**BUILDING INSPECTION PERMIT**

has permission to amendment permit #090180 - revise floor plan

RE: Building Permit #090180 – PowerPay Offices, Renovations to the former Portland Public Market building.

From Designer: Stephen Weatherhead, Project Architect- Winton Scott Architects  
 Date: April 3, 2009  
 Job Name: PowerPay Offices- Renovations to the Portland Public Market  
 Address of Construction: 320 Cumberland Avenue

PLAN OF TYP PENETRATION IN EXIST FLOOR DECK

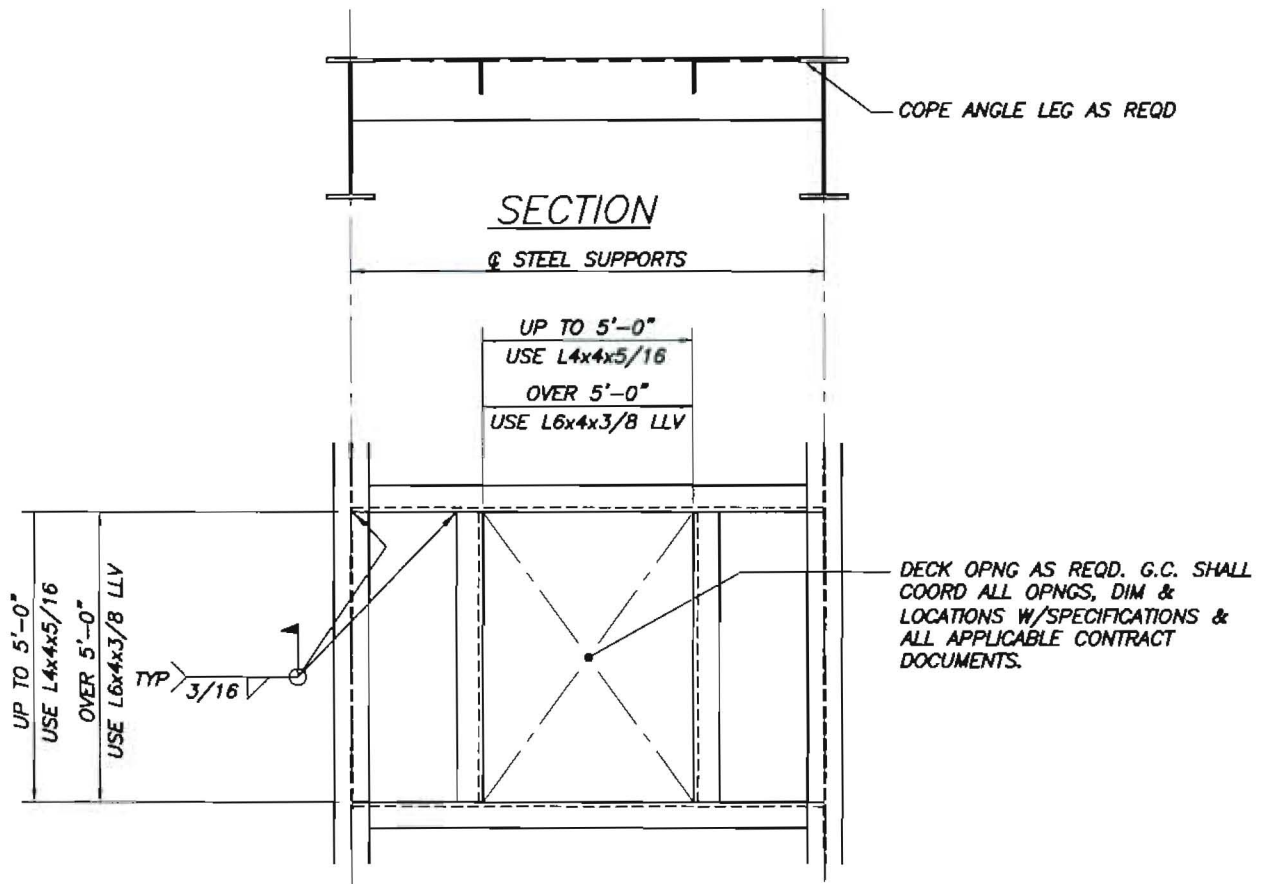
DETAIL TYPICAL IF OPENING IS LARGER THAN 12"Ø OR CUTS MORE THAN (1) DECK RIB. FOR OPENINGS LESS THAN 12"Ø, REINF OPNG W/16GA MIN PL. MIN PL LENGTH SHALL BE "D"+4". EXTEND AS REQD FOR 2" MIN BRG ON DECK RIB.

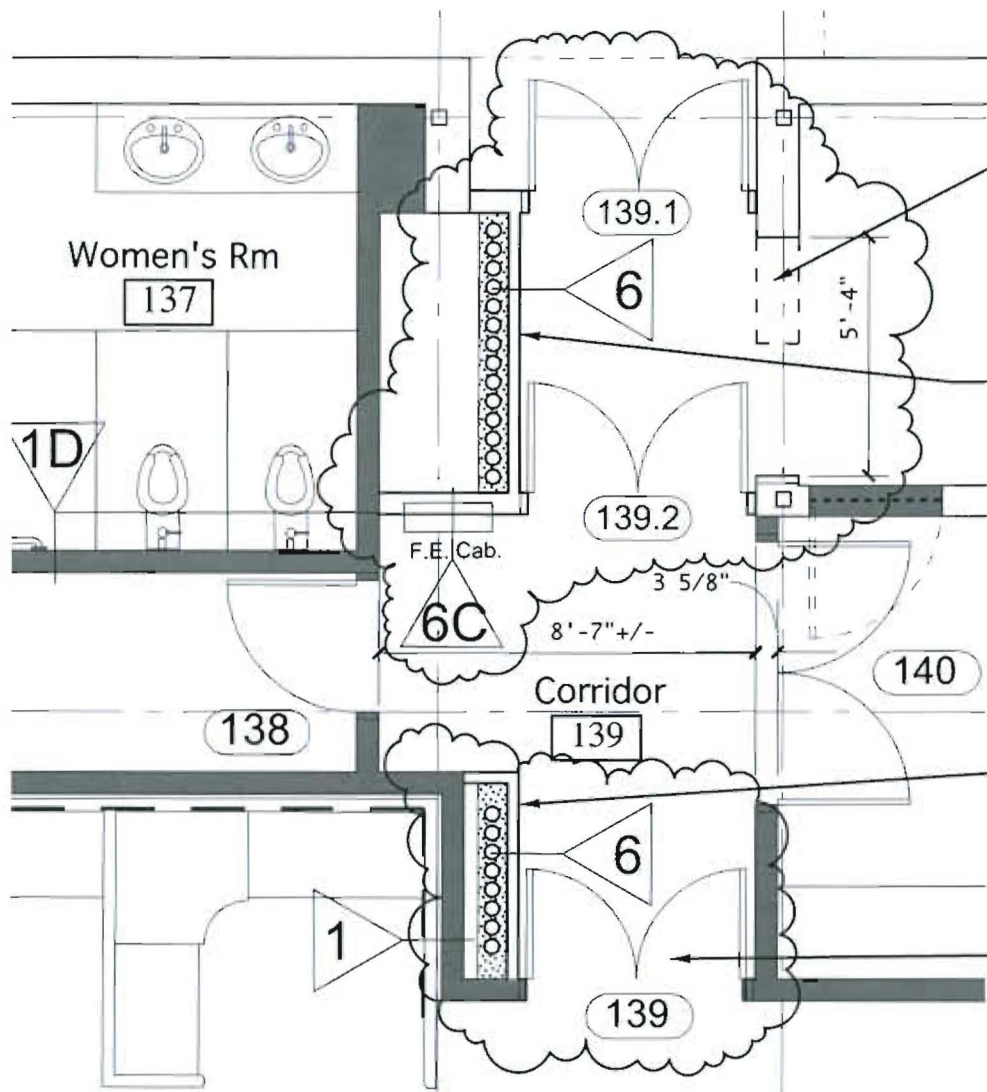
New electrical chase as shown. Firestop conduits at slab

New electrical chase as shown. Firestop conduits at slab

FIRST FLOOR PLAN REVISIONS AT STAIR 4  
Scale: 1/4" = 1'-0"

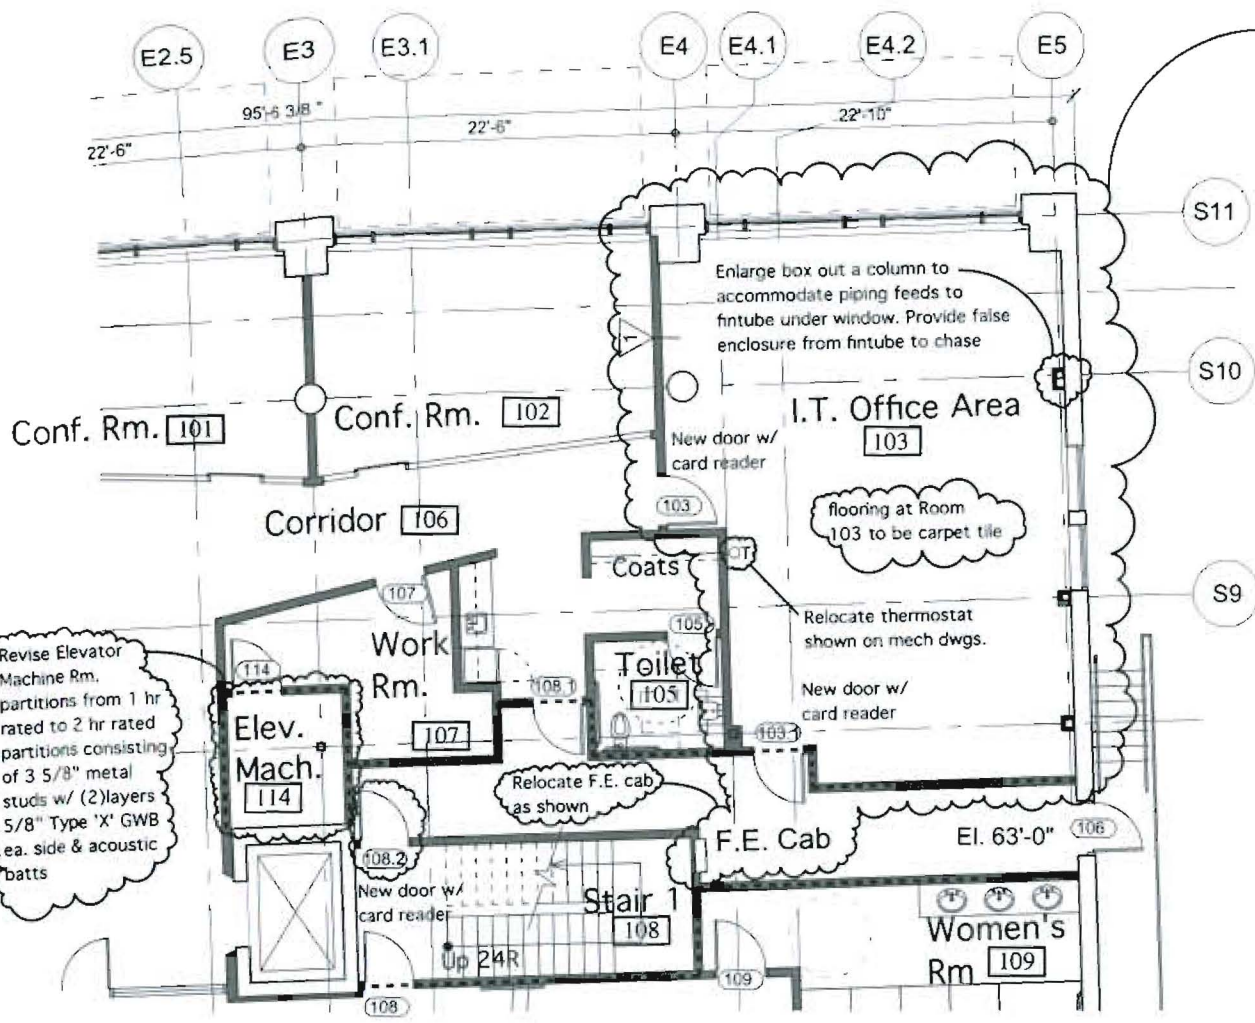
Doors 139, 139.1, 139.2 shall all be pairs of 2'-6"x7'-0" with panic hardware. Door 139 requires smoke seals and Door 139.2 shall have a 60 minute label. All are type 'A' doors. Door dtls H1/J1 apply to doors 139, 139.2. Details for Door 139.1 are similar to dtls H3/J3

Revise interior partition layout and provide two new doors as shown to eliminate two conference rooms & create an open office area as shown.

Revise Elevator Machine Rm. partitions from 1 hr rated to 2 hr rated partitions consisting of 3 5/8" metal studs w/ (2)layers 5/8" Type 'X' GWB ea. side & acoustic batts

Enlarge box out a column to accommodate piping feeds to fintube under window. Provide false enclosure from fintube to chase

**FLOOR PLAN**  
 SCALE: 3/32" = 1'-0"

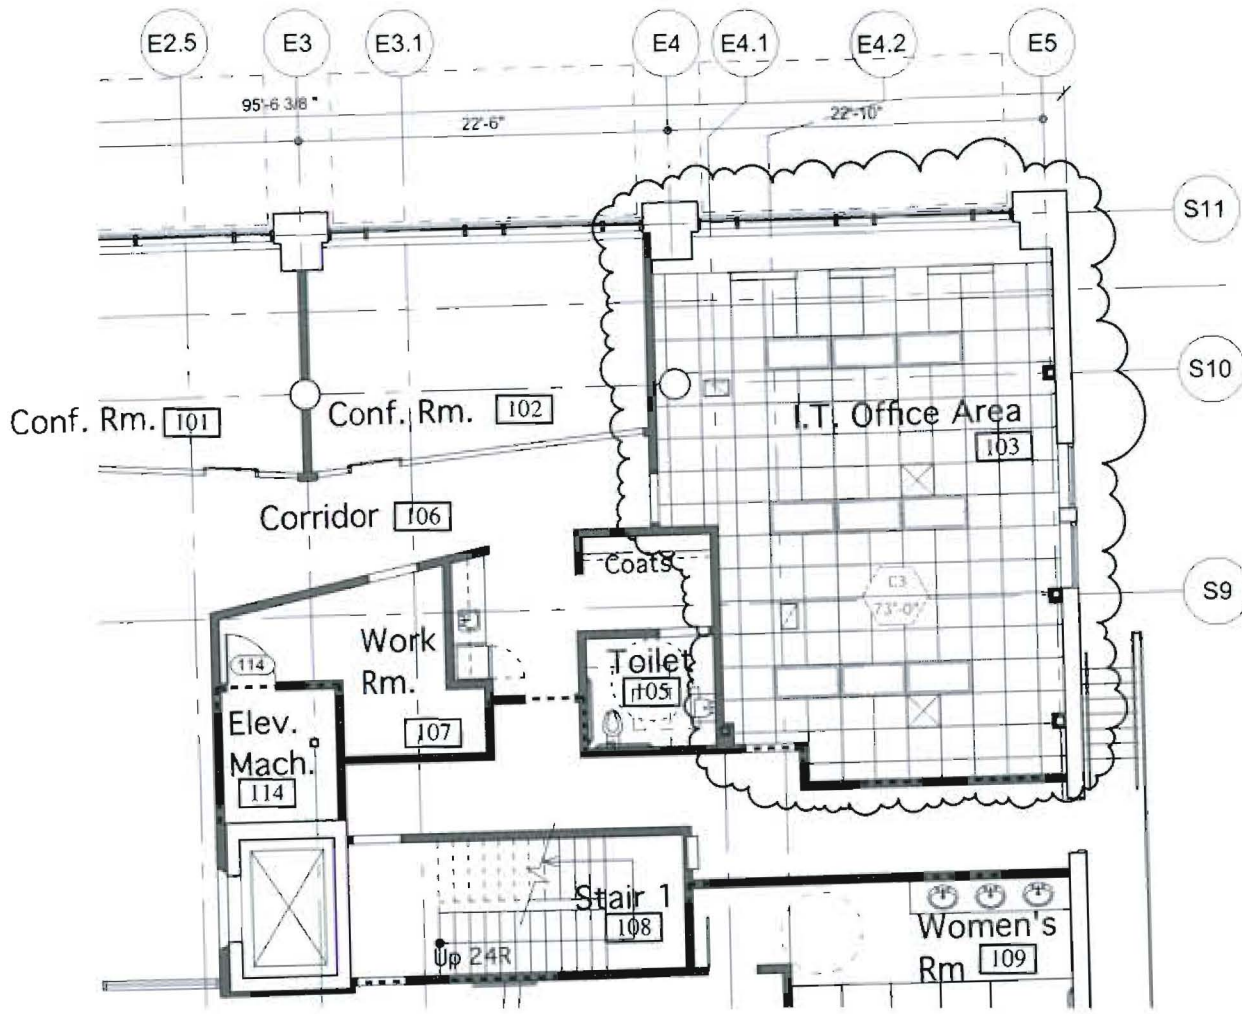
flooring at Room 103 to be carpet tile

Relocate F.E. cab as shown

**CEILING PLAN**  
 SCALE: 3/32" = 1'-0"

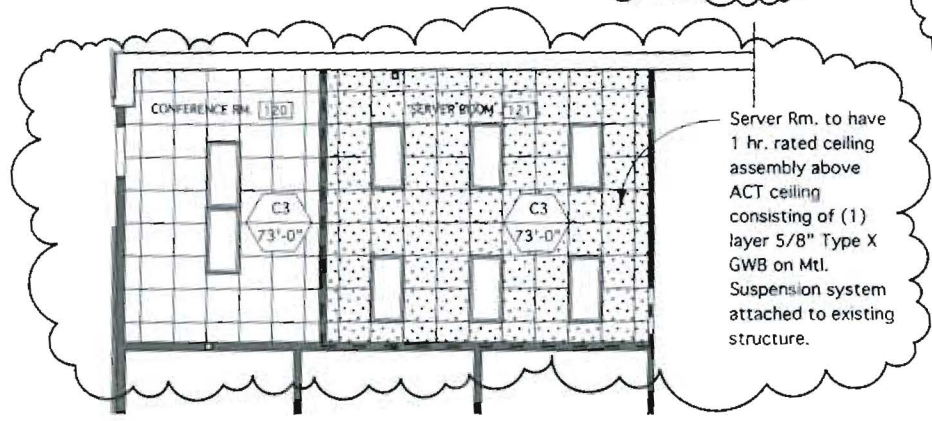
**Door 121:**  
 3'-6" x 7'-0"  
 solid core wood,  
 door type 'A', frame  
 type 'F1'. 60 min. label  
 & smoke gasketing.
